Consensus Results: Corrections Needed in Clause 180.9.6

Norman Swenson
Affiliated with Nokia, Point2
Aug 31, 2026

Addresses Comments: R2-15, R2-16, R2-17, R2-18, R2-126, R2-141, R2-144, R2-188, R2-189, R2-206

Figure 180–10—TDECQ reference equalizer functional model

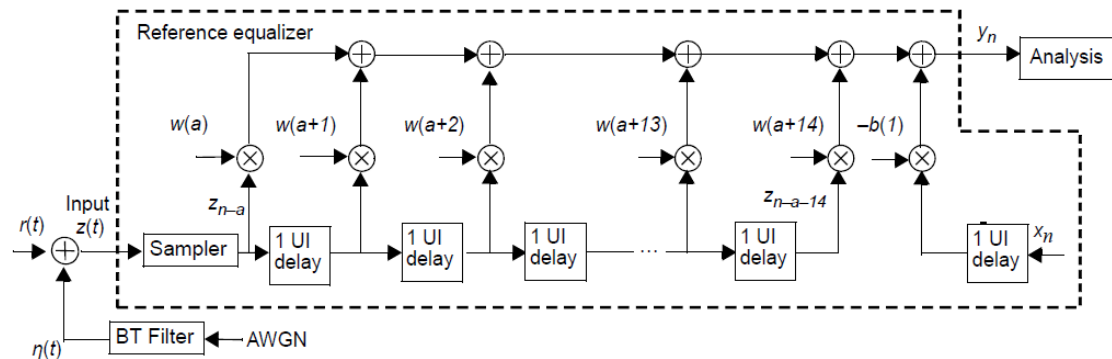
The equalizer is modeled as shown in Figure 180–10, where

- $r(t)$ is the output of the reference receiver defined in 180.9.2, with the mean value subtracted from the signal
- $\eta(t)$ is colored Gaussian noise, generated from additive white Gaussian noise (AWGN) filtered by a Bessel-Thomson (BT) filter as defined in 180.9.2

- $z(t)$ is the input signal given by Equation (180–1)
- z_n is the sampled response of input signal $z(t)$, given by Equation (180–2)
- v_n is the equalizer output corresponding to x_n

- X_n is the n th symbol in the test pattern sequence, $X_n \in \{0, 1, 2, 3\}$, and x_n is given by Equation (180-3)
- ~~w is the set of feed-forward tap coefficients, given by Equation (180–3)~~

- ~~a vector of feed-forward tap coefficients, given by Equation (180-4)~~
- $b(1)$ is the feedback tap coefficient
- ~~the feedback is modeled as correct, i.e., x_n is the pattern used to generate the input $r(t)$~~

- decisions are modeled as being correct, i.e., the decision feedback path is fed by the sequence $\{x_n\}$ corresponding to the transmitted test pattern sequence without errors

- the received signal $r(t)$ is aligned with the test pattern such that $r(nT)$ corresponds to x_n

$$x_n = 2/3 X_n - 1, \quad x_n \in \{-1, -1/3, 1/3, 1\} \quad (180-3)$$

$$\mathbf{w} = [w(a), w(a+1), \dots, w(a+14)] \quad (180-4)$$

Figure 180–11—Illustration of the TDECQ measurement

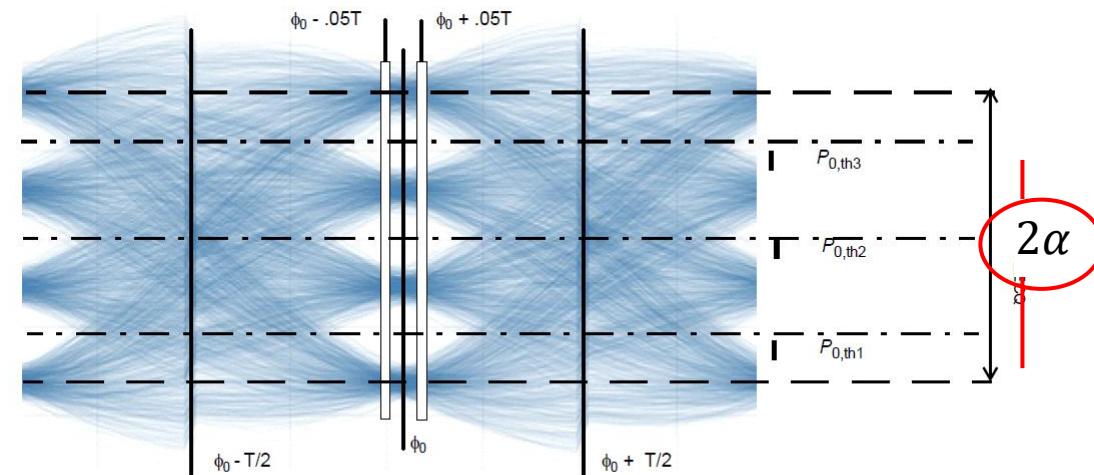
$r(t)$ is no longer a power, as the mean has been subtracted off, and y_n is a discrete-time signal, not a continuous-time signal. The method defined in 180.9.5 is for a continuous-time signal with runs of threes and runs of zeros. If we define the thresholds in terms of α (the scaling factor applied to x_n), we do not need to define OMA_{TDECQ} at all.

Original:

An eye diagram to help illustrate TDECQ is shown in Figure 180–11. The eye diagram corresponds to the optimized equalizer setting at sampling phase ϕ_0 . The feedback symbol x_n changes at phase $\phi = \phi_0 - T/2$.

An eye diagram to help illustrate TDECQ is shown in Figure 180–11. The eye diagram corresponds to the optimized equalizer setting at sampling phase ϕ_0 . The feedback symbol ~~x_n changes at phase $\phi = \phi_0 - T/2$.~~

x_{n-1} changes value to x_n at time $t = nT + \phi_0 + T/2$.

The eye diagram can be constructed, for example, by using the equalizer taps optimized at ϕ_0 and varying the phase ϕ in Eq. 180-2 to generate samples y_n at multiple phases.

The nominal threshold levels $P_{0,th1}$, $P_{0,th2}$, and $P_{0,th3}$, are ~~determined from the OMA_{TDECQ} and the average optical power P_{ave}~~ defined in Equation (180-4), Equation (180-5), and Equation (180-6), and illustrated in Figure 180-11.

$$P_{0,th1} = \cancel{P_{ave} + \frac{OMA_{TDECQ}}{3}} - \frac{2\alpha}{3} \tag{180-4}$$

$$P_{0,th2} = \cancel{P_{ave}} - 0 \tag{180-5}$$

$$P_{0,th3} = \cancel{P_{ave} + \frac{OMA_{TDECQ}}{3}} + \frac{2\alpha}{3} \tag{180-6}$$

~~where OMA_{TDECQ} is measured on the equalized captured waveform y_n using the method defined in 180.9.5~~,
where α is the scaling factor applied to x_n to achieve an MMSE fit to y_n where the tap coefficients in w sum to 1.
